Agenda Item 7: **Redwood Grove Bank Stabilization, Project CF-01001 (J. Gustafson)**

Comment on Preliminary Plan for Redwood Grove Stream Project

Redwood Grove Nature Preserve
Adobe Creek Bank Stabilization Project 12 August 2014

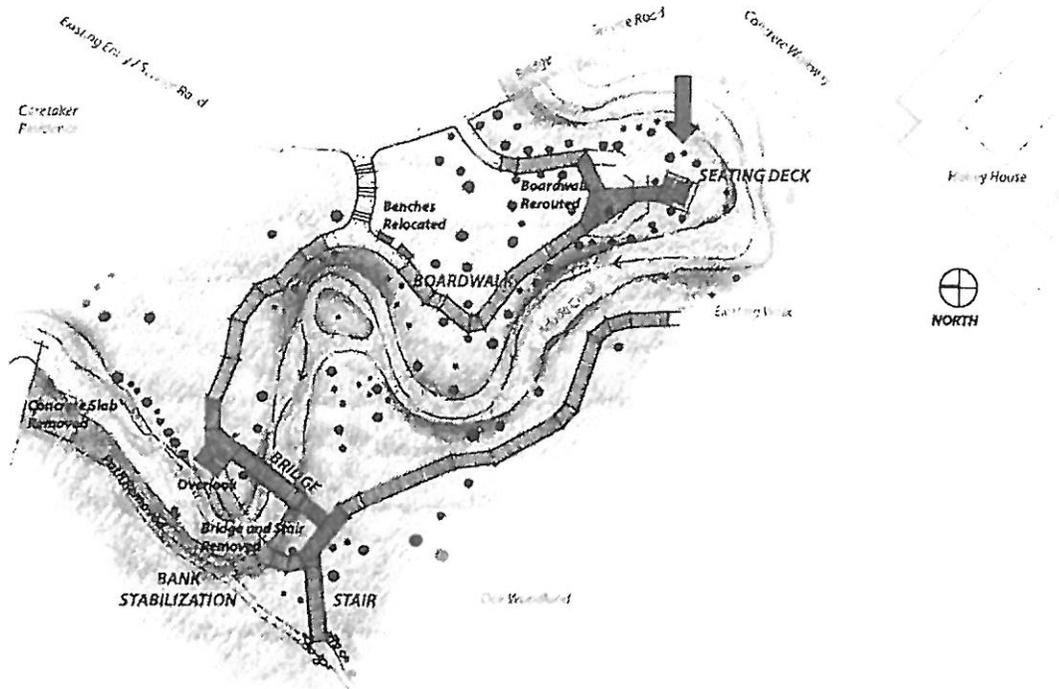
The plan as posted includes a pullback of the boardwalk from the floodplain, which is a good thing. But it also envisions the addition of new construction in this area, including a "seating deck" as shown:

This new construction simply exacerbates the incursion of vulnerable wood and concrete construction into the floodplain, with the attendant need for more future repair work.

At first glance this area would appear to be immune to flooding, since it is well above the deepest part of the existing stream channel. But in fact, it is in the area flooded every time we get heavy rains and should therefore be eliminated from the plan in the interests of economy and preservation of the stream in a natural state.

As you can see, the proposed seating area is right in the path of the flood and would have been inundated and possibly damaged had it existed in past flood years.

Ill-advised concrete and wood construction in the past has led to the situation which requires this expensive stream repair project today. We should avoid repeating past bad design choices. NOW is the time to correct these design flaws, before this gets into the realm of public debate and rancor. I urge you to amend the design as soon as possible.
